Project	IEEE 802.16 Broadband Wireless Access Working Group < http://ieee802.org/16 >	
Title	Enhancement of Pre-authentication of PKMv2	
Date Submitted	2005-01-24	
Source(s)	Chulsik Yoon, Mi-young Yun, and Sungcheol Chang	csyoon@etri.re.kr
	ETRI 161, Gajeong-dong, Yuseong-Gu, Daejeon, 305-350, Korea	
Re:	Contribution on comments to IEEE P802.16e/D5	
Abstract	In this contribution, we propose to enhance the pre-authentication concept to the various cases of authorization modes.	
Purpose	Adoption	
Notice	This document has been prepared to assist IEEE 802.16. It is offered as a basis for discussion and is not binding on the contributing individual(s) or organization(s). The material in this document is subject to change in form and content after further study. The contributor(s) reserve(s) the right to add, amend or withdraw material contained herein.	
Release	The contributor grants a free, irrevocable license to the IEEE to incorporate text contained in this contribution, and any modifications thereof, in the creation of an IEEE Standards publication; to copyright in the IEEE's name any IEEE Standards publication even though it may include portions of this contribution; and at the IEE

Figure 1. Description of the PKMv2 Key Hierarchy

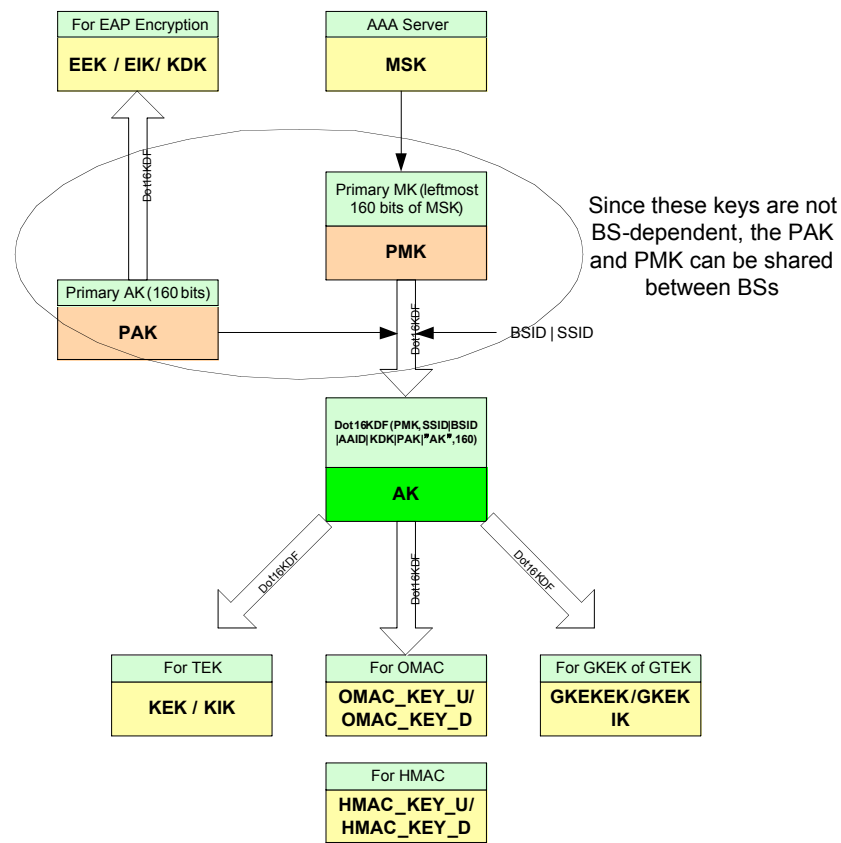
In Figure 1, the general PKMv2 key hierarchy concept is described.

Currently, the Pre-authentication is applied to the PMK, not PAK. In Figure 1, only the right branch of the key hierarchy tree can be applied the pre-authentication for fast handover. But for most of the cases including the left branch of the key hierarchy tree (the RSA only case, RSA with EAP yielding an MK case, and the RSA with EAP not yielding an MK case), the pre-authentication cannot be applied.

To enhance this mechanism to every case of the authentication mode, the MSS and the target BS shall share not only the PMK, but also the PAK. During the HO procedure the serving BS transfer the MSS's capability information to the target BS, and then the target BS know the authorization capability of the MSS. Therefore, the MSS and the target BS can generate the same AK using the same AK generating rule for the initial network entry procedure, without PKM message transaction between them over the air.
